Wylfa Newydd Project

Audit of the Wylfa Hydrodynamic Model

Document Reference Number: ML-HDM-01-WHDM

Second Review

Figure 2. Location of long term temperature monitoring sites

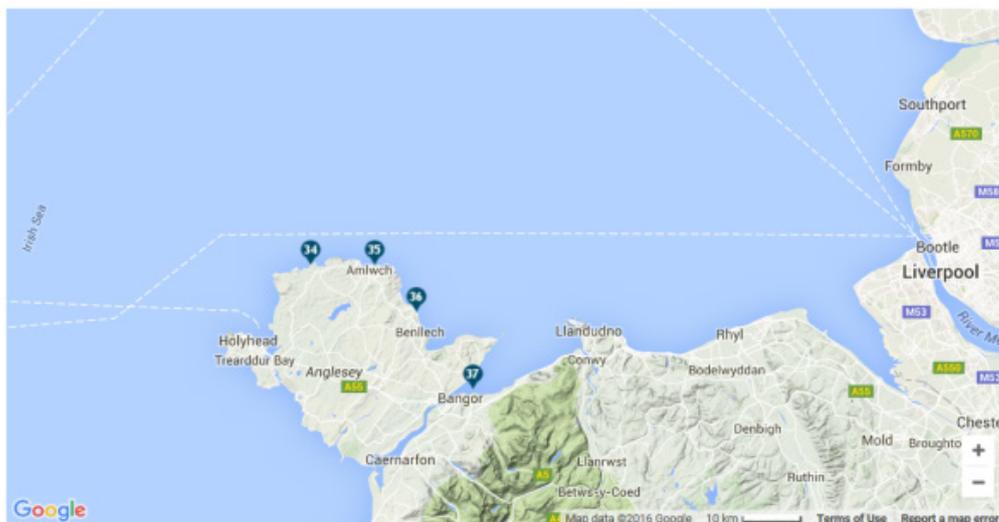
This data is regarded as being complimentary to the oceanographic survey observations; however, the relative depth of any measurement is unknown at this time as well as the relative influence from any local thermal discharge. The thermal plume from Wylfa 'A' may therefore provide some local bias to measurements at Site 34, which may limit the information being used directly to develop any background ambient temperature.

This data is offered in terms of deriving monthly and annual statistics to "add" to modelled temperature excess results for the new outfall and to help derive an equivalent absolute temperature value. However, since the sample location and period would appear to be inclusive of the operation of Wylfa 'A', then the influence of the local thermal plume is likely to remain within these observations.

Figure 3. Comparison of long term monthly mean water temperatures

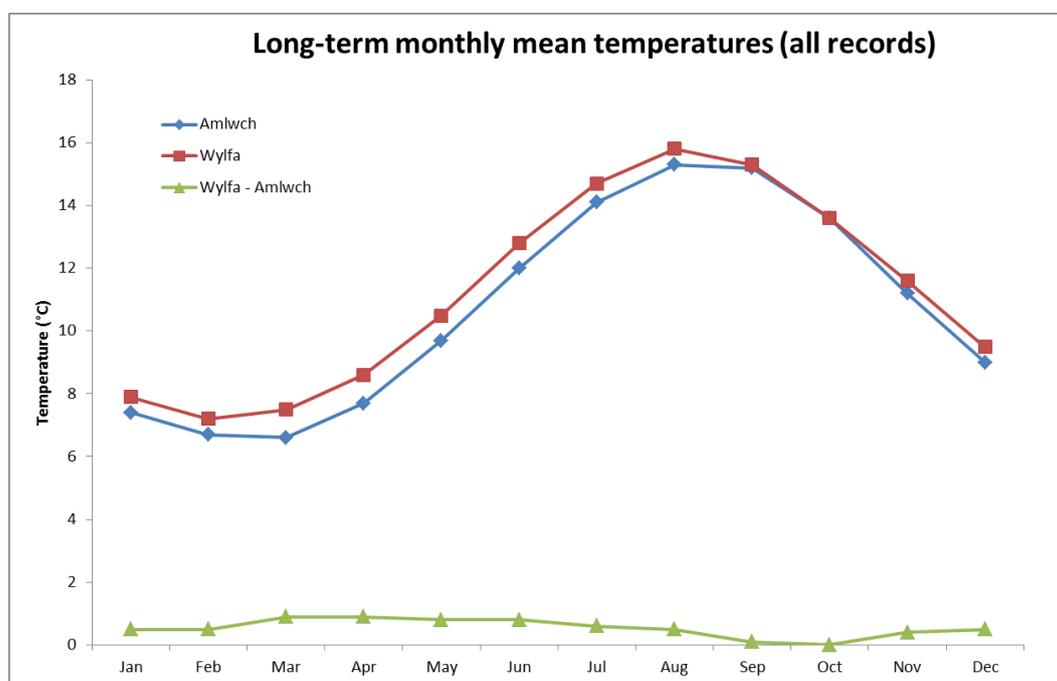
- Amlwch is an industrial headland with marine discharges (anthropogenic influences), although the nature of these discharges are unknown to the review process at this time.
- Both Amlwch and Wylfa are on the north coast of Anglesey and would expect to experience similar variations in seasonal heating and cooling in seawater.
- The long-term monthly mean temperature data presented in Figure 3 shows a consistent higher temperature at Wylfa in comparison to equivalent data at Amlwch, as expected. This increase is as much as 0.9°C in the period March and April down to 0.0°C in October.
- The difference between Wylfa and Amlwch mean temperatures may also be evidence of the influence of a variable heat loss rate and a pattern which tallies well with estimates of seasonal heat loss coefficients (Jacobs, 2015b), with lowest values in spring and highest values in autumn.

Whilst the Supplementary Information correctly asserts that natural variations are greater than the differences due to any local warming from a thermal plume, the additional comparison offered here helps to illustrate the likely influence of a thermal plume on increasing the ambient temperatures and the relevance of a variable heat loss rate

Figure 5. Location of available BODC records

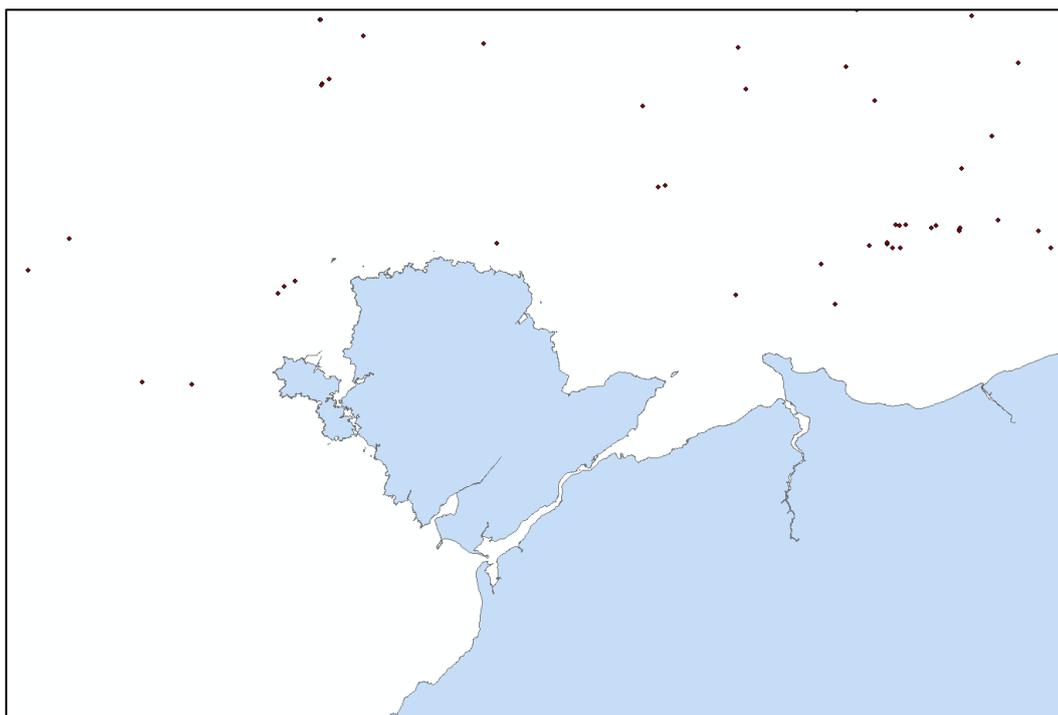
Whilst Phase 1 modelling made use of a single BODC data location in Liverpool Bay, Figure 5 shows the distribution of other locations which are closer to Wylfa and potentially more applicable to the Phase 2 model domain. These sites remain useful in terms of demonstrating model performance over a wider area, especially those shown to be present of the north coast of Anglesey and for the likely footprint of tidal excursion from any thermal plume suggested by the drogue observations.

The most appropriate BODC records to accept to help demonstrate the performance of the model are those measurements which approximate a mid-depth position and where the quality of the information is not flagged with any issues. Hence, Sites 14695 and 15987 are to be considered as most appropriate. The remaining data should not be considered as part of model proving and can be filtered out on grounds of insufficient quality or limited applicability. The additional consideration of model performance at Sites 14695 and 15987 helps to add confidence to the Outer Grid and the far-field, noting that this model supports issues where the advection of material from the Inner Grid passes through to the Middle and Outer Grids.

Figure 6. Local LiDAR DTM data (from lle.go.wales)

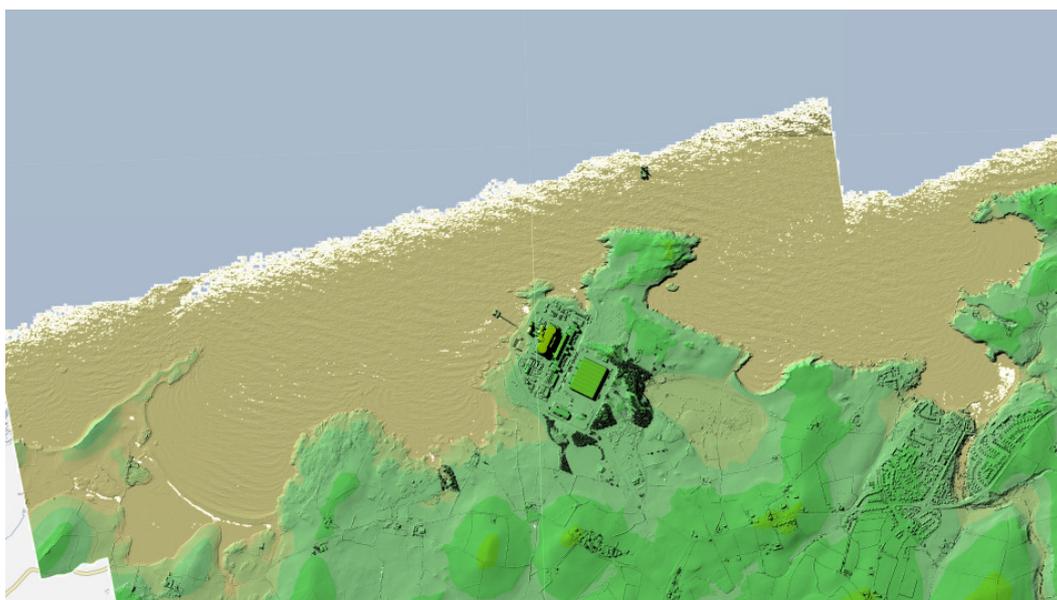
The first review commented on the value of presenting the local surveyed bathymetry (Figure 1.6 in Titan 2012) versus equivalent modelled bathymetry, for the area east and west of Wylfa Head, and to help demonstrate how well the complex coastline and (sub-tidal) bathymetry within the local bays is described by the model. Figure 7 provided in the Supplementary Information does not fully achieve this as the presentation is coloured at a coarse interval and presented as points not contours.

The Supplementary Information also now provides comment in relation to the method of developing the composite bathymetry and the method of visual inspection to validate the process.

Figure 7. Thermal discharge from Wylfa 'A' Magnox power station into Porth Wnal.

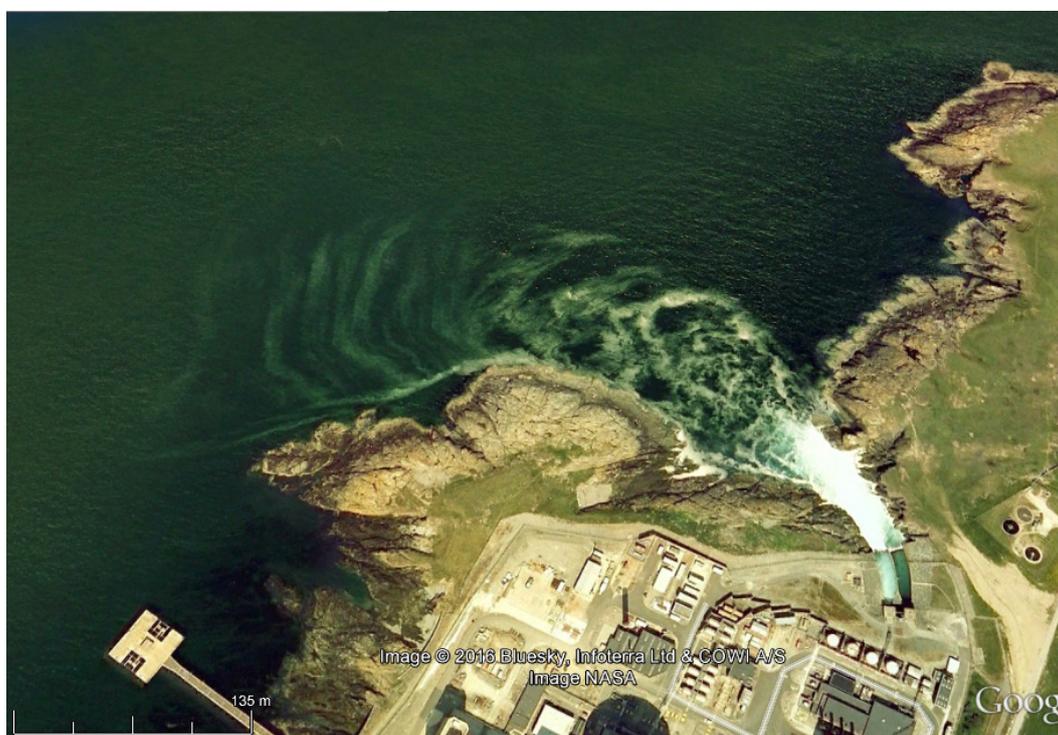
In addition, given the high discharge rate from the open channel outfall, this feature should be investigated as a flux boundary in the Phase 2 hydrodynamic model as there will be momentum imparted to the local flow (visible in Figure 1) which may have important influences on local flow circulations that are presently not fully resolved. For reference, the flow rates described for the cooling water discharge of 68 to 83 m^3/s (HNP, 2015a) would be equivalent to a large river flow such as the Mersey. For context, the mean flow rate for the River Conwy is around 19 m^3/s , with a 10% exceedance value of around 46 m^3/s .

Within the confines of Porth Wnal the discharge volume and rate of discharge is likely to be dominant over any tidal influence and create complex and strong turbulent flows (Figure 8 below) which are beyond the capability of Delft3D. This area is noted in HNP (2015a) as white water extending approximately 50 m from the outfall, however the period shown in Figure 8 shows extent is around 300 m (equivalent to 13 grid cells at 23 m each). The model should still aim to retain the general influence of this strong flow as a discharge boundary for scenarios representing the thermal discharge as the same structure is being proposed to serve as the Wylfa 'A' outfall and with a discharge rate which is expected to be greater than for Wylfa 'A', which would arguable extend further into the bay. The use of CORMIX for estimating near-field mixing is relatively redundant given the high discharge and proposed configuration of the new outfall. Further comment is offered in Section 7.6 below.

Figure 8 Interpretation of seabed from 2009 bathymetric survey in the vicinity of S9 and C1

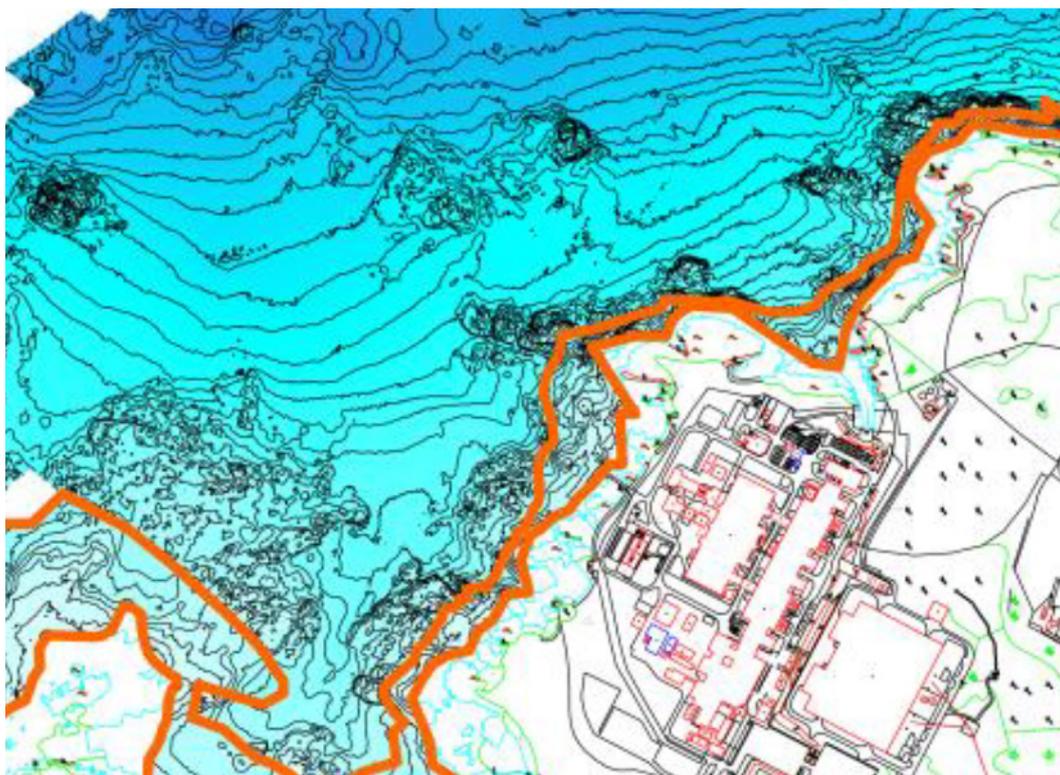
C1 is a similar location to S9 observations from 2011, noting modelled flows from S9, as presented in HNP (2015b), did not compare well to the measured data and especially in relation to tidal phase. The profile of the local seabed in the vicinity of S9 and C1, as illustrated in Figure 1.6 of Titan (2012), suggests some local subtidal irregularities extending off the coast as well as away from the coast (see Figure 9 below), which may have some influence on the local flow characteristics. It is not immediately clear if the same features are represented in the gridded bathymetry shown in Figure 6 of Supplementary Information (this comments links with Section 6.3.2).

The new comparisons of model performance at C1 for flow speed and direction appear to show a much better correlation of tidal phase throughout the short observation period than was previously shown for S9 in HNP (2015b). The additional consideration to make in this comparison is that C1 is stated as being 7.7 m above the seabed in a local depth of 18.1 m (plus tidal variation above and

below this depth), whereas the modelled flows are presented as depth average values. At times of greatest deviation on the spring tide the water depth is closer to 20 m (Figure 12 of Supplementary Information) meaning C1 at these times is around a third of the water depth. The true deviation between a mid depth and depth average comparison is therefore likely to be greater than presented.

Figure 9. Terrain map of Anglesey (from Google Map)

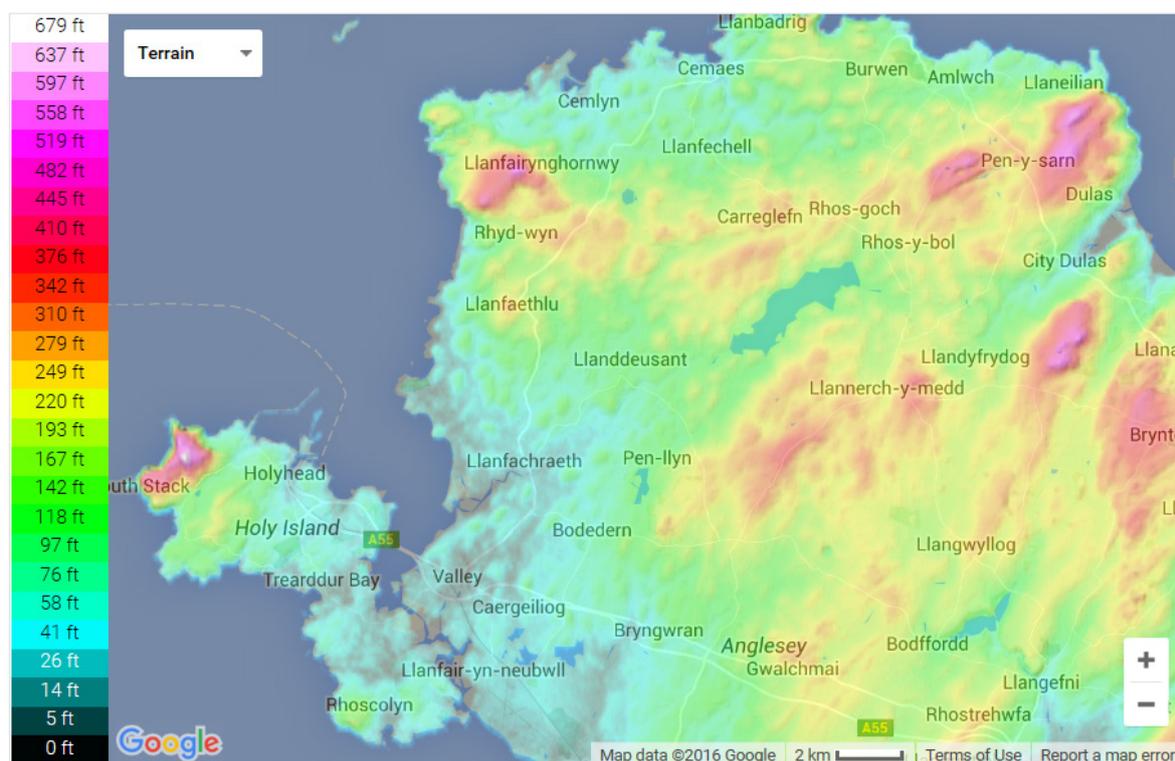
In comparison, Wylfa is exposed to sea breezes from west to north to easterly sectors but is relatively sheltered from the south by a belt of higher ground which is generally over 200 feet above sea level (Figure 10).

The absence of any locally measured wind data from Wylfa 'A' is surprising. A recommendation is made from this audit to obtain some local measurements and compare with equivalent observations to help verify the suitability of RAF data as a site for representative wind data, even if this was a short period of a few months.
